## **Shelby County Airport Mass Storage Hangar T**

### **ADDENDUM NO. 2**

Date: September 15, 2023

DRAWING NUMBER  
**ED-1.01**

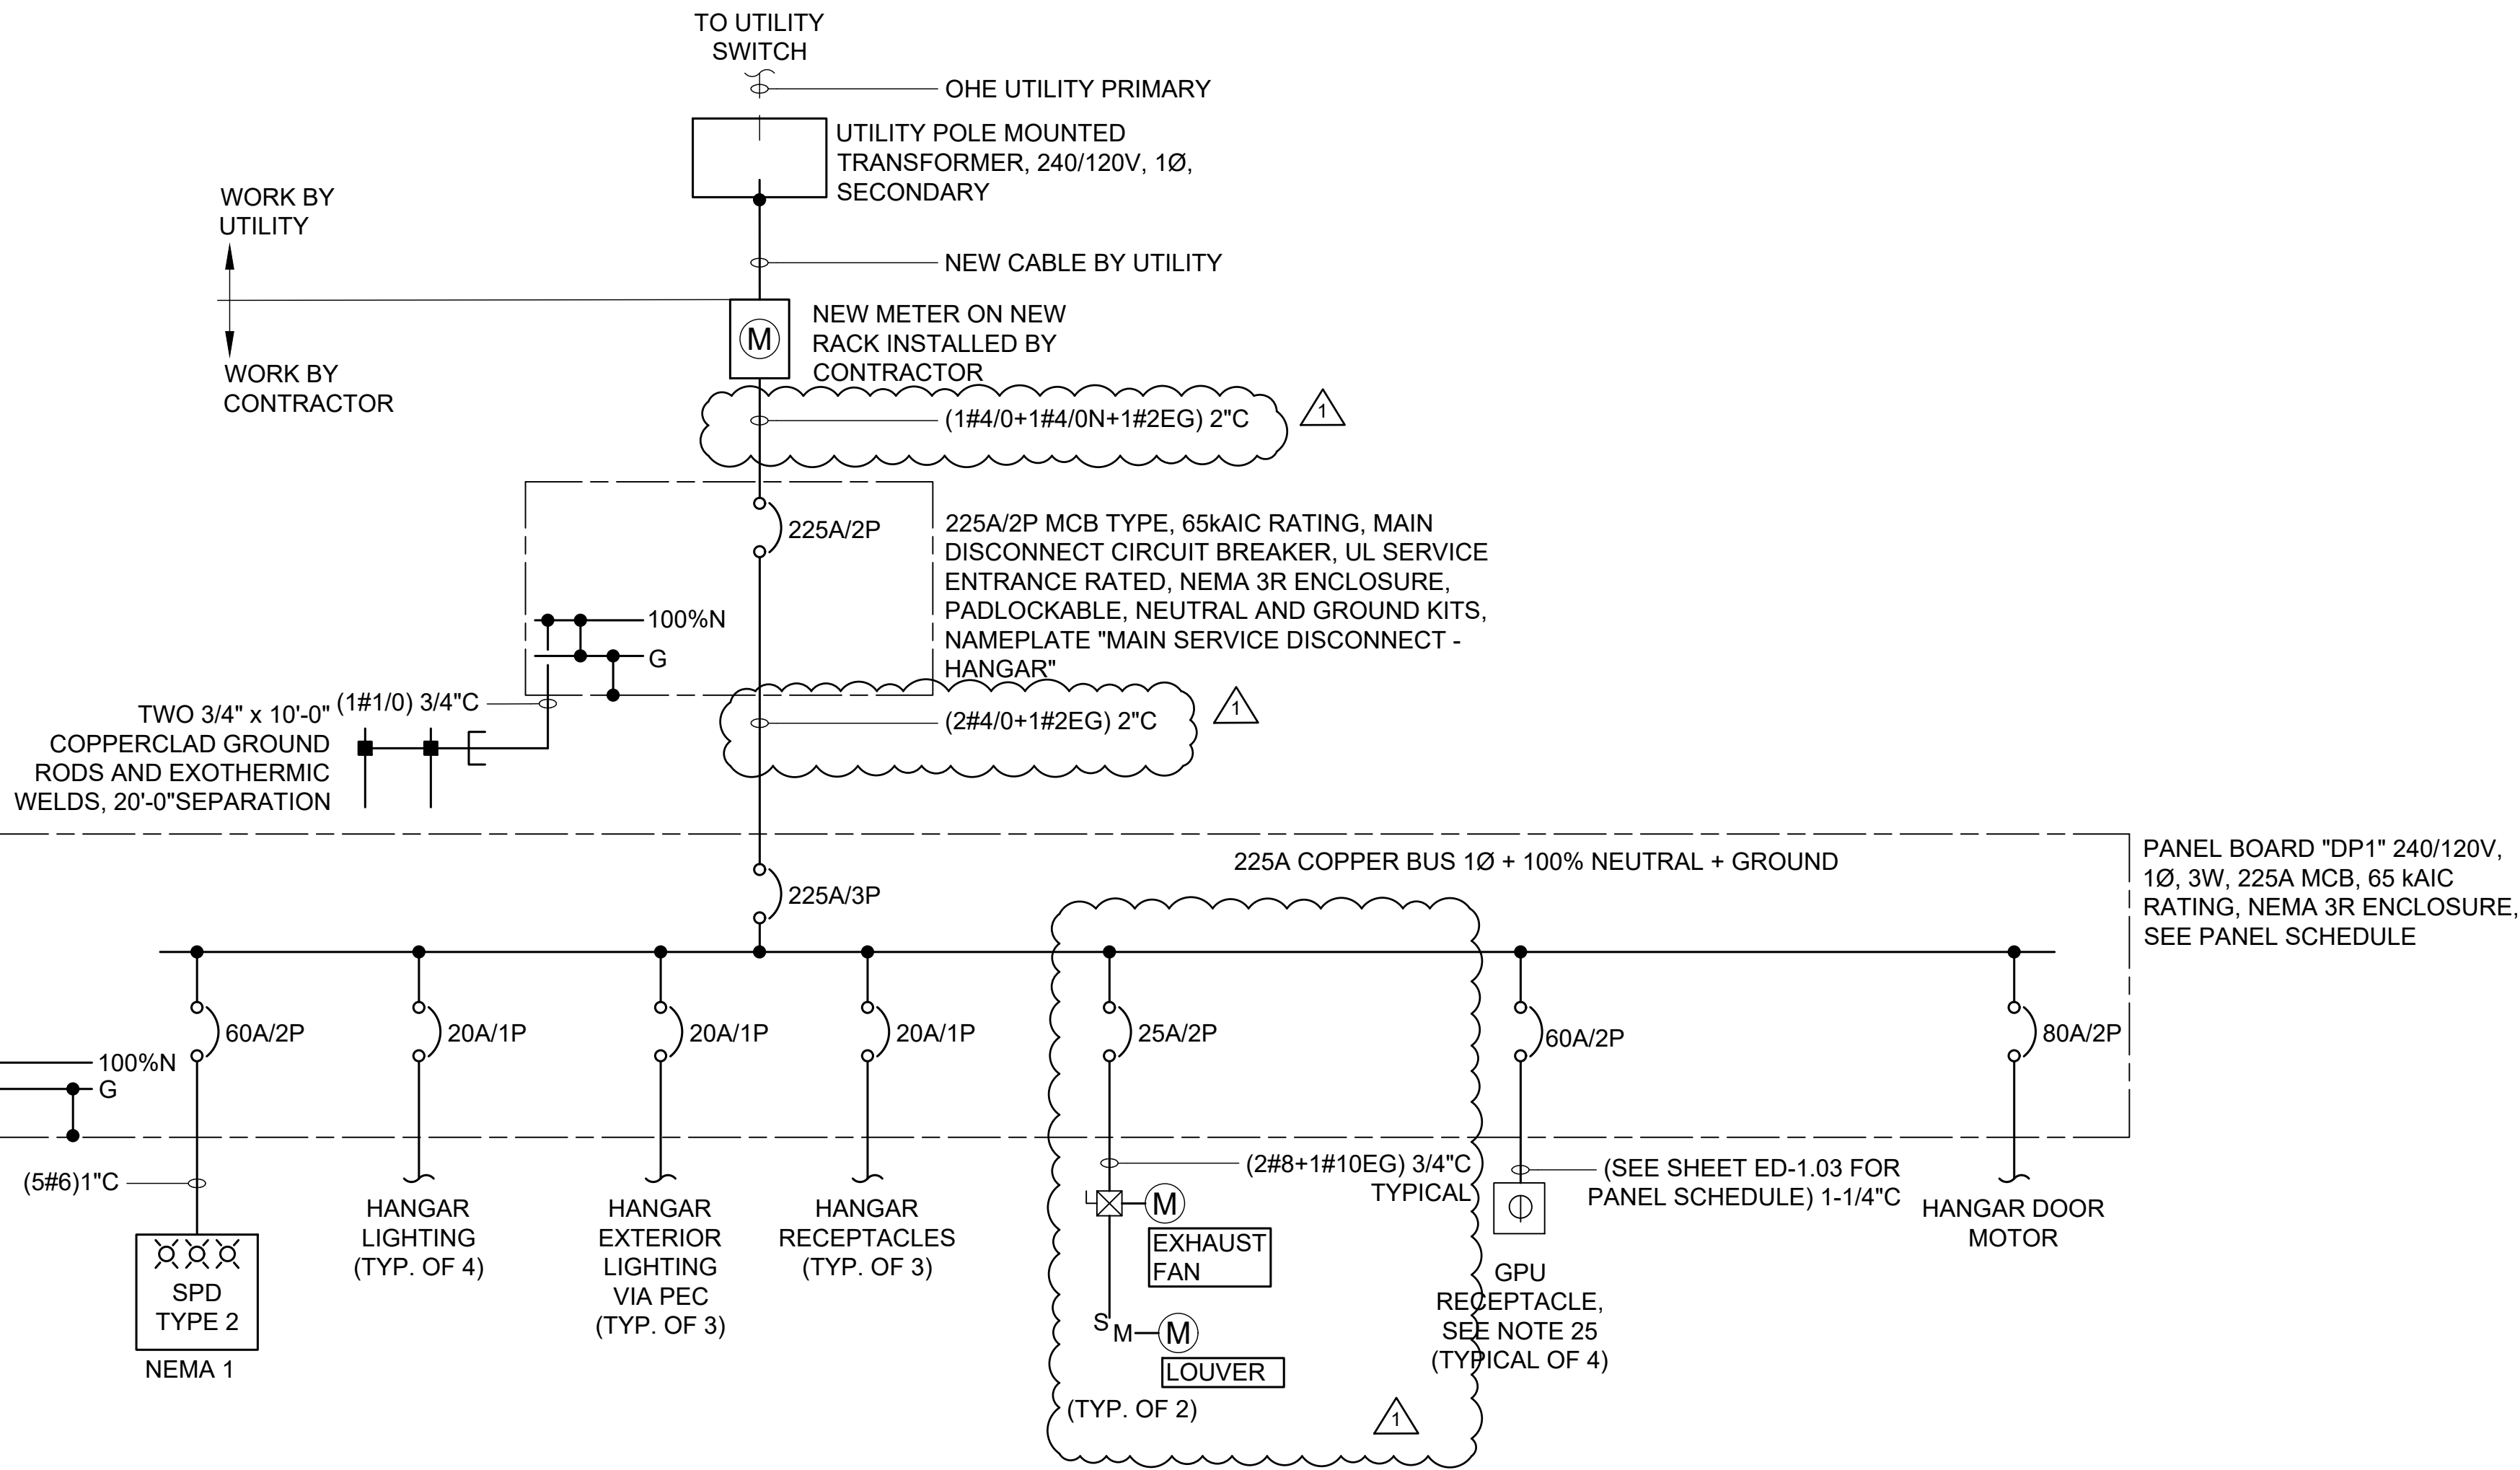
- See attached revised Sheet ED-1.01
  - Additional details and requirements have been included for the exhaust fan and intake louvers
  - The wire size feeding the hangar has been updated to a 4/0 cable
  - The breaker and wire size for the exhaust fan circuits have been updated to the manufacturer recommendation for the exhaust fan shown in the equipment schedule
- See attached revised Sheet ED-1.03
  - The equipment schedule has been added for the exhaust fan and louvers used in the design
  - Additional details and requirements have been included for the exhaust fan and intake louvers.
  - The panel schedule has been revised to show the specific load information and size of the exhaust fans
